SUBJECT: Entergy Nuclear Operations, Inc. Vermont Yankee Nuclear Power Station Docket No.: 50-271 License No.: DPR-28

> Technical Specification Proposed Change No. 266 <u>Revision to Control Rod Operability, Scram Time Testing and Control Rod</u> <u>Accumulators</u>

LETTER NUMBER: BVY 04-60

# Proposed Technical Specification Change No. 266

3.3 LIMITING CONDITIONS FOR OPERATION

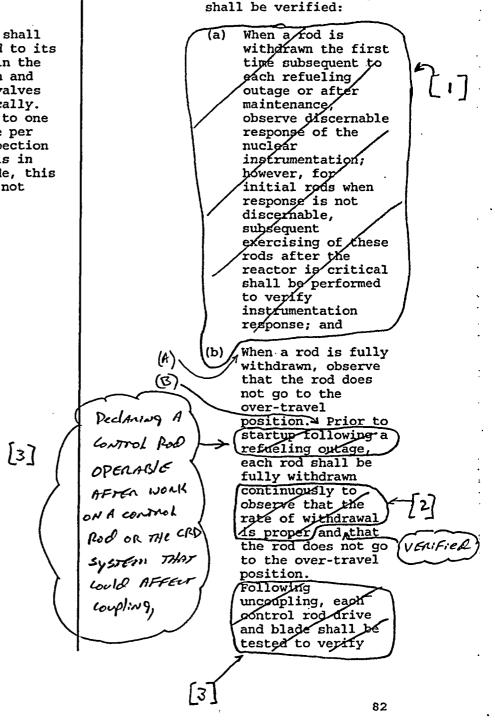
> disarmed electrically except for control rods which are inoperable because of scram times greater than those specified in Specification 3.3.C. In no case shall the number of inoperable rods which are not fully inserted be greater than six during power operation.

- B. Control Rods
  - Each control rod shall be either coupled to its drive or placed in the inserted position and its directional valves disarmed electrically. When removing up to one control rod drive per quadrant for inspection and the reactor is in the refueling mode, this requirement does not apply.

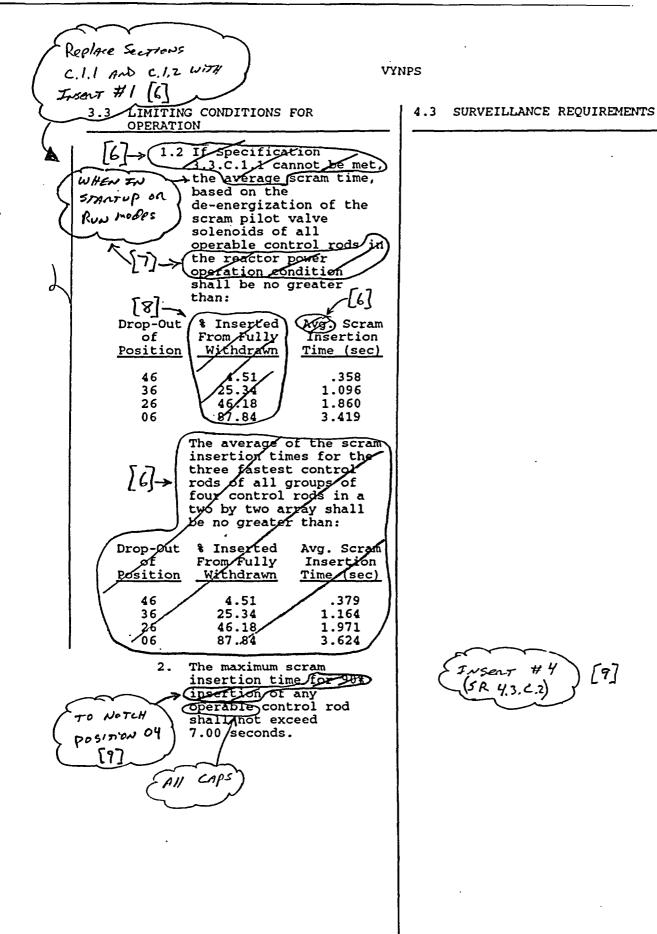
VYNPS 3.3 LIMITING CONDITIONS FOR 4.3 SURVEILLANCE REQUIREMENTS OPERATION 7. The scram discharge Replace. Sections volume drain and vent Replace C. I.I And C. I. 2 WITH Insent # 1 [6] valves shall be verified д Sections C.1. open at least once per month. These valves may And C.2 be closed intermittently WITH INSENTS for testing under administrative control. #2 + #3 c. Scram Insertion Times c. Scram Insertion Times [19] 1.1 The average scram time, After refueling outage 1. based on the and prior to operation de-energization of the above 30% power, with And Price To scram pilot valve reactor pressure above 6-16 Exceeding solenoids of all 800 psig all control operable control rods h rods shall be subject to 30% RTP AFTER the reactor power scram-time measurements operation condition EACH REALMA from the fully withdrawn shall be no greater . position. The scram SHUTDOW than: times for single rod Z IZO DAYS scram testing shall be Drop-Out \* Inserted Avg. Scram measured without of From Fully Insertion reliance on the control Position Withdrawn Time (sec) rod drive pumps. [יי] 46 4.51 0.358 During or following a EACH 200 BAYS 0.912 36 5 25.34 controlled shutdown of 1.468 26 46.18 the reactor, but not cumularive more frequently than 06 87.84 2.686 OPENATION IN 16 weeks nor less The average of the scram frequently than 32 weeks RUN MODE, FOR A intervals, 505 control rod drives in each quadrant of the reactor insertion times for the -[12] REDNESENTATIVE three fastest control rods of all groups of sample four control rods in a core shall be measured two by two array shall for scram times be no greater than: specified in Specification 3.3.C. All control rod drives Drop-Out \* Inserted Avg. Scram From Fully shall have experienced Insertion of soram-time measurements each year. Whenever 50% Of the control rod Position Withdrawn Time (sec) . 46. **4**∖51 0.379 0.967 36 25.34 drives scram times have 1.556 been measured, an 26 46.18 [3] 🚓 87.84 2.848 evaluation shall be made 06 to provide reasonable assurance that proper control rod drives performance is being maintained. The result; of measurements performed on the control rod drives shall be submitted in the start up test report.
